Re: Sub-Petition No. 1293-PLCPB-01 - Request for Access Road Change in Lisbon

Change in Access Road from Mell Road in Lisbon to an alternative location on Mell Road for Structures 7151, 7151A and 7152

The requested access road change is located approximately 265 feet west of the approved access road location off Mell Road and is shown as "Proposed New Access Road" on the revised Map Sheet 7 dated January 30, 2019 (see Attachment A).

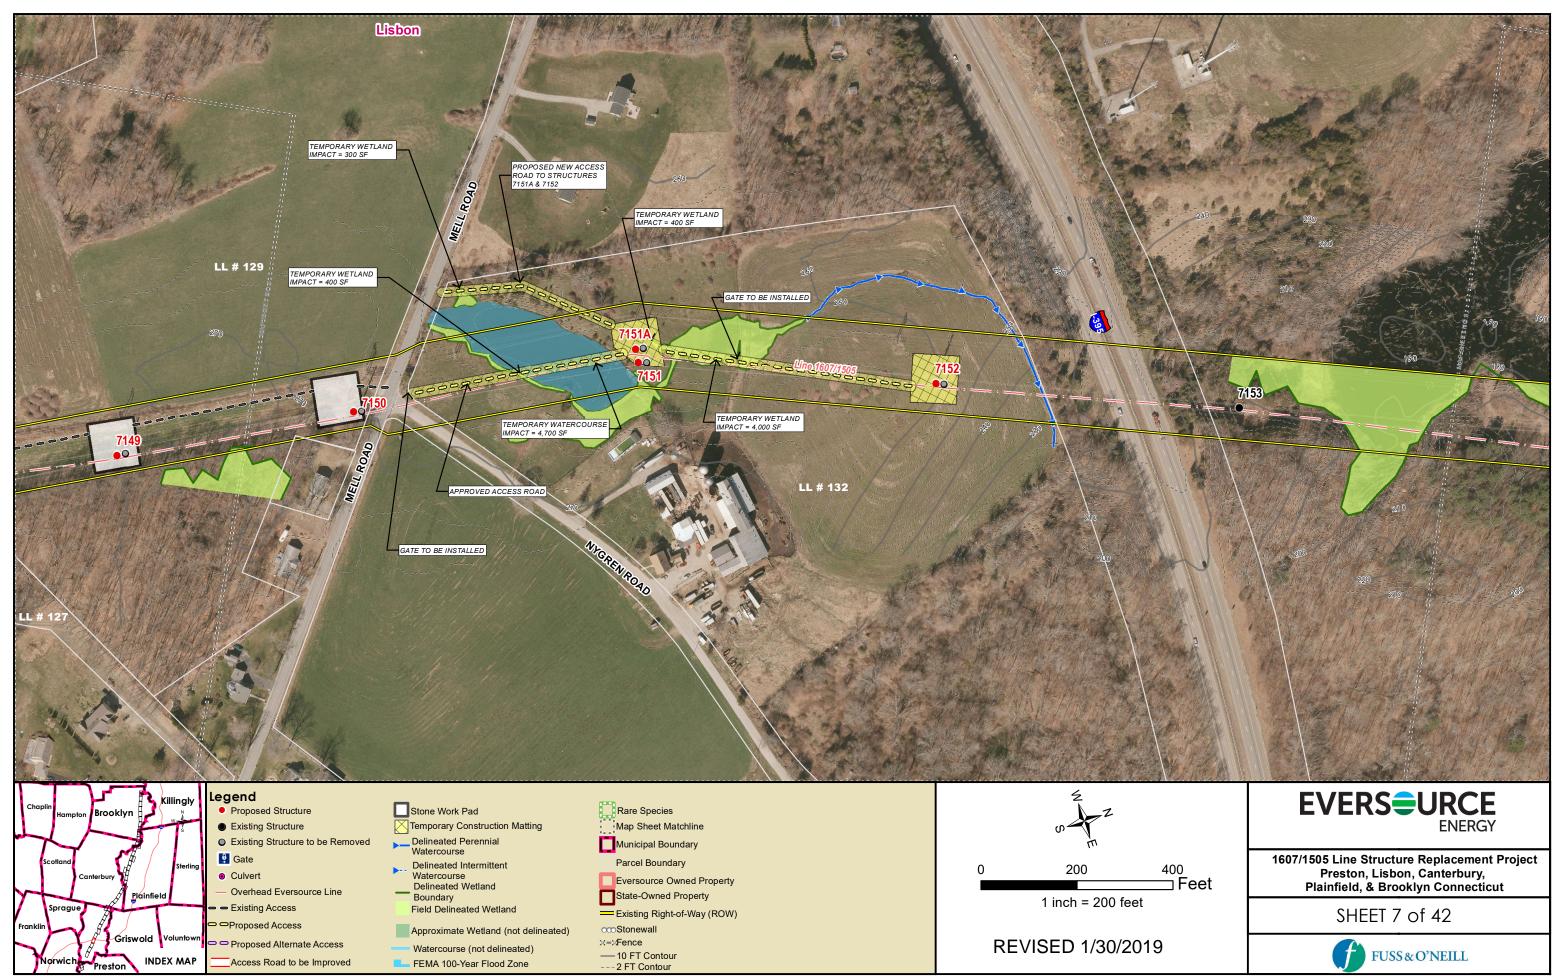
In the sub-petition filing, Eversource had shown access to Structures 7151, 7151A and 7152 by entering the Eversource ROW off Mell Road, near the intersection of Nygren Road, and traversing the ROW by constructing a temporary access road utilizing timber matting. This access would have required spanning a watercourse and wetland area with approximately 4,700 square feet ("SF") of temporary watercourse impact and approximately 400 SF of temporary wetland impact. After further discussion with the property owner it has been determined that the watercourse crossing could be eliminated by accesses the property further west on Mell Road. The proposed new access road would eliminate the watercourse impact and reduce the temporary wetland impact by 100 SF. As detailed on the revised map sheet 7, the proposed temporary access road would be constructed with timber matting to avoid the watercourse before entering the ROW and continuing to structures 7151, 7151A and 7152. Upon completion of the project the temporary matting would be removed, and the areas restored, as necessary.
